## ASSESSMENT REPORT

### PROPOSED MODIFICATION GINKGO MINERAL SANDS PROJECT

Figure 2: Section showing modified overburden replacement method

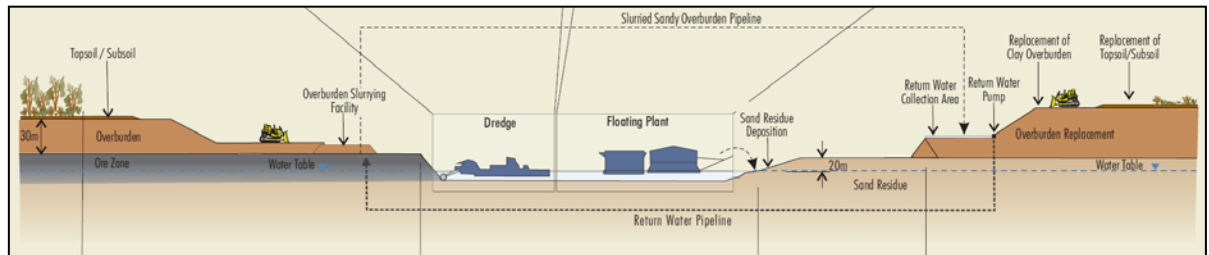
The modification proposes to slurry the sandy overburden, and transport the slurry via pipeline to the overburden replacement area or the northern initial emplacement. The northern emplacement would need to be expanded by about 15 hectares to cater for the revised method.

The **Department of Natural Resources** does not object to the proposal, but raised concerns regarding the potential for salinity-related impacts associated with the proposed slurry overburden replacement method, and particularly the potential for salinity to affect the success of rehabilitation, especially trees. This issue is discussed in Section 5 below.

The water in the dredge pit, which is sourced mainly from the underlying aquifer, is highly saline. This saline water, if not controlled properly, has the potential to impact upon land and water resources by increasing soil salinity.

The Department and the DNR raised a number of concerns regarding the potential for salinity-related impact, including:

- the potential for saline water to leak from the slurried material deposited in the aboveground overburden emplacement to the surrounding environment;
- the adequacy of the proposed 3 metre (minimum) capping layer, particularly given the potential for salts to rise up through the capping layer via 'capillary rise', and therefore affect the likely success of rehabilitation;
- the potential for salts in deposited slurry material to become airborne (via wind erosion) and therefore affect the surrounding environment by raising salinity levels.

With regard to the adequacy of the 3 metre (minimum) capping layer, the Applicant provided additional assessment from its specialist rehabilitation consultant, Dr Darren Brearley. Dr Brearley cites research conducted on mineral sands mining rehabilitation projects in WA which suggests that capillary rise can occur up to 2 metres above a saturated zone (ie. a groundwater table or perched aquifer). Dr Brearley suggests that capillary rise at Ginkgo, where the final emplacement is well above a saturated zone, is likely to be much less than 2 metres.

The DNR considers that, over time, some of the deeper rooted perennial species in the area (particularly native trees) would potentially be affected by saline overburden placement to within 3 metres of the surface. The DNR considers that a buffer in the order of 6-7 metres would be more appropriate, given uncertainties associated with:

- the response of native woodlands to increased salt loading higher up in the soil profile;
- the potential for capillary rise of salts (which is highly variable and dependent on number of factors including clay content and heat); and
- the leaching fraction of salts over time.

Given this rehabilitation goal, and the uncertainty associated with the likely long term success of woodland rehabilitation, the Department believes that a precautionary approach should be adopted to ensure that the proposal would result in a minimal environmental impact. In this regard, the Department believes that the Applicant should be required to establish a compensatory vegetation offset area that is equivalent to the area that may be affected by the saline overburden placement. The Department considers that a conservatively reasonable threshold for the potentially affected area is the area subject to a capping layer of 5 metres or less, which equates to a total area of 245 hectares.

In summary, the Department believes that the proposed change to the overburden replacement method can be conducted in a manner that would ensure a minimal environmental impact to land and water resources, subject to requiring the Applicant to:

- update its existing management plans – including the Integrated Erosion and Sediment Control Plan, Site Water Management Plan and Land Management Plan – in consultation with the DNR and other relevant agencies, to accommodate saline overburden placement; and
- establish an additional compensatory vegetation area of 245 hectares as a precaution against the potential failure of rehabilitation above areas of saline overburden placement.

Figure 3: Modified site layout, Year 1 (showing enlarged northern initial overburden emplacement)

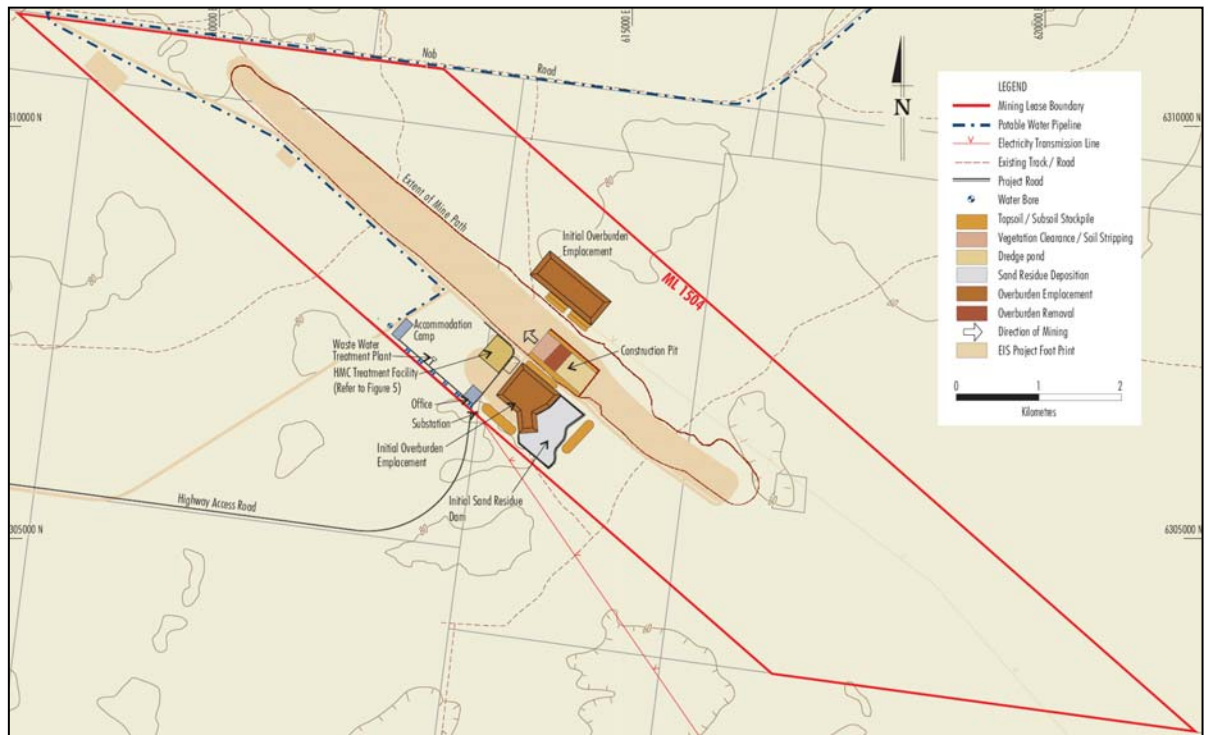
The consent allows the replacement of overburden via an overland conveyor system. Overburden is excavated from in front of the advancing dredge mining operation, and transported via conveyor to behind the mined area, which is progressively rehabilitated (concept shown on Figure 2). Overburden removed during the first months, when there is insufficient area behind the dredge pond, would be deposited in an overburden emplacement on the northern side of the mining area (see Figure 3).

With regard to saline water leakage from the northern initial overburden emplacement, the Applicant provided additional information on how it would control saline water infiltration from the emplacement. The control measures to be employed would include:

The proposed modification would require the direct removal of approximately 15 hectares of Belah (Casuarina) Woodland, associated with the expansion of the northern initial emplacement. The approved Project requires disturbance to some 600 hectares in total.

- a compacted 360mm clay liner at the base of the emplacement to minimise infiltration, with the liner covered with 200mm of sand to prevent cracking of the liner;
- a low permeability embankment surrounding the emplacement to prevent lateral leakage;
- a toe drain(s) to collect seepage water for recycling back to the dredge pit; and
- a groundwater monitoring network surrounding the emplacement to monitor potential leakage.

In consideration of these mitigation measures, and recognising that the nearest off-site groundwater user is located some 12 kilometres from the mining lease area, the Department and the DNR are satisfied that the proposal is unlikely to result in any

The existing consent requires the Applicant to develop and implement a Southern Mallee Offset Strategy that provides for the conservation and management of Southern Mallee vegetation removed by the Project. Accordingly, the Department has recommended increasing the required offset by 15 hectares to compensate for the area disturbed by the proposal. This offset area could be established in a variety of ways (such as acquiring and conserving an area of similar Southern Mallee vegetation and habitat value, or rehabilitating and conserving an area of degraded habitat), with the detail to be provided in the approved offset strategy.
